STAFF REPORT AMENDED 11-8-84
CITY PLANNING COMMISSION

- APPLICATION:
- A. Negative Declaration
 - B. Rezone 0.48 acre from A to R-2B-R
 - C. Plan Review for development of 194 unit apartment complex on 10.6+ vacant acres in the Garden Apartment-Review (R-2A-R, R-2B-R & A) zones
 - D. Lot Line Adjustment to merge two lots totalling 3.46 acres

RUSH RIVER APTS. PHASE II

EXHIBIT A #5

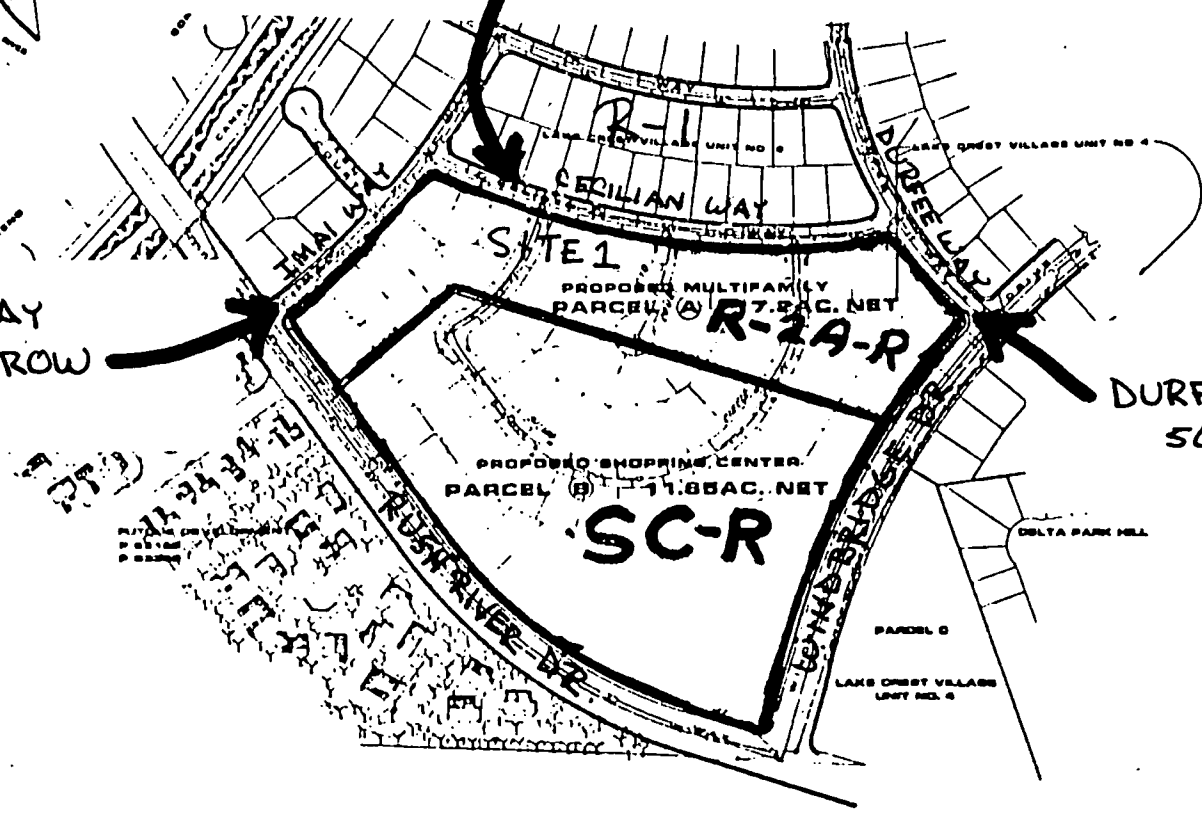
The single family lots to the north are separated by minor residential streets with street right-of-way widths as follows (refer to Exhibit A).

Imai Way - 50' right-of-way
Cecilian Way - 44' right-of-way
Durfee Way - 50' right-of-way

EXHIBIT C

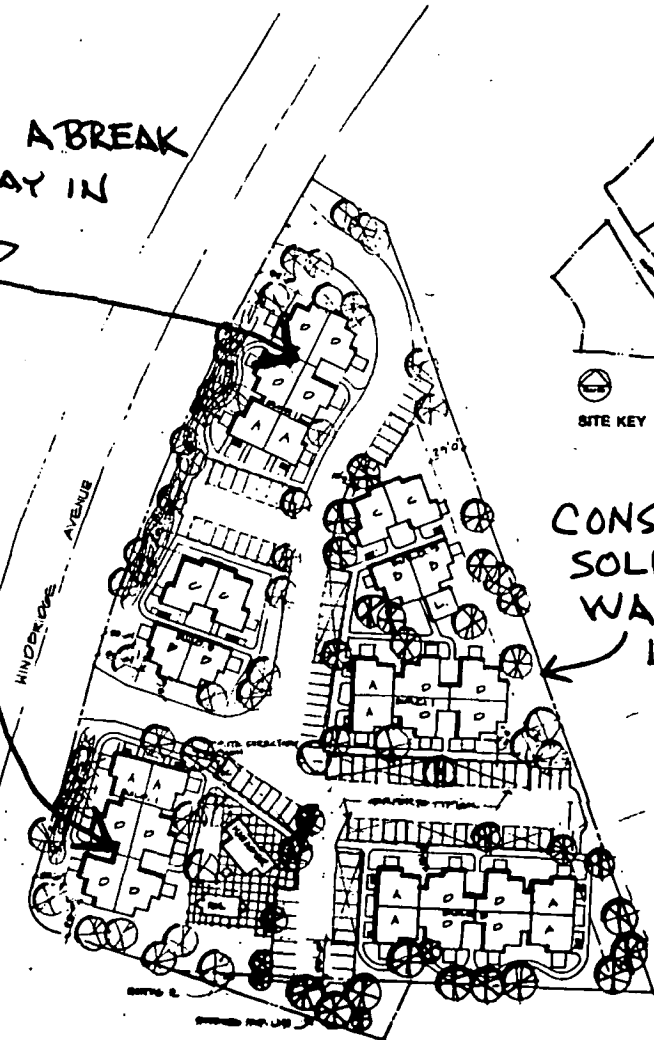
The modification requested to the site plan for site 2 is a break in the two twelve-unit clusters along Windbridge Drive as indicated in Exhibit C to allow shorter walking distance from the front units to the off-street parking spaces, thereby minimizing the likelihood of on-street parking by the apartment tenants.

* INCORPORATE A BREAK OR BREEZEWAY IN BLDG

CONSTRUCT 6' HIGH SOLID MASONRY WALL ON PROPERTY LINE.

1. ~~The two 12 unit buildings on Windbridge Drive shall be modified with a breezeway as shown on Exhibit C. (CPC deleted)~~
2. A six foot high solid decorative masonry wall shall be constructed along the side/rear property lines adjacent to the single family lots as shown on Exhibit C.

ELEVATIONS

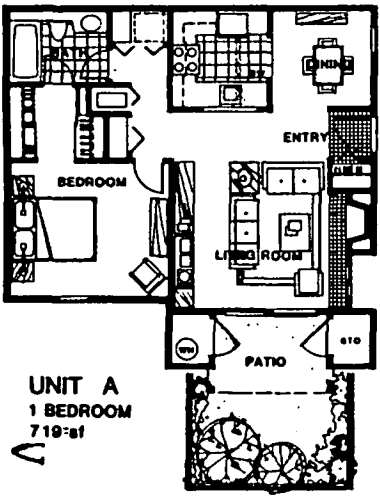
- (a) Extend a pitched roof over the flat roof sections to give a more finished look to the buildings. Ridge to be same height as ridge over side porches (refer to Exhibit D).
 - (b) Incorporate sections of stucco material in combination with the horizontal masonite lap siding in one of the two projects and use different width of lap siding within each project.
 - (c) Stair railings and stringers to be encased or covered with wood.
 - (d) Paint each project a different color with a contrasting color trim.
 - (e) Provide different roof material for each project.
2. Landscape Plan - The landscape setback areas along the public street frontages on both sites shall be bermed to a minimum height of four feet and intensively planted with large growing shade trees to further screen the complex from adjacent single family homes and from street view.

* EXTEND PITCHED ROOF OVER
FLAT ROOF SECTIONS AT THE SAME HEIGHT AS THE
RIDGE OVER THE SIDE PORCHES.

MATCH RIDGE
OVER SIDE
PORCH

MATCH RIDGE OVER
SIDE PORCH

1. The final architectural plans including paint colors and roofing materials shall be submitted to the Planning Director for review and approval prior to issuance of building permit. The building design shall be modified as follows:
 - (a) ~~A pitched roof shall be extended over the flat sections of the building at the same height as the ridge over the side porches. (CPC deleted)~~
 - (b) ~~Stair railings and stringers shall be enclosed by a decorative with wood. (CPC deleted)~~
 - (c) Each project shall be painted with a different primary color with contrasting color trim. A color palette shall be submitted to the Planning Director for review and approval prior to issuance of building permit.
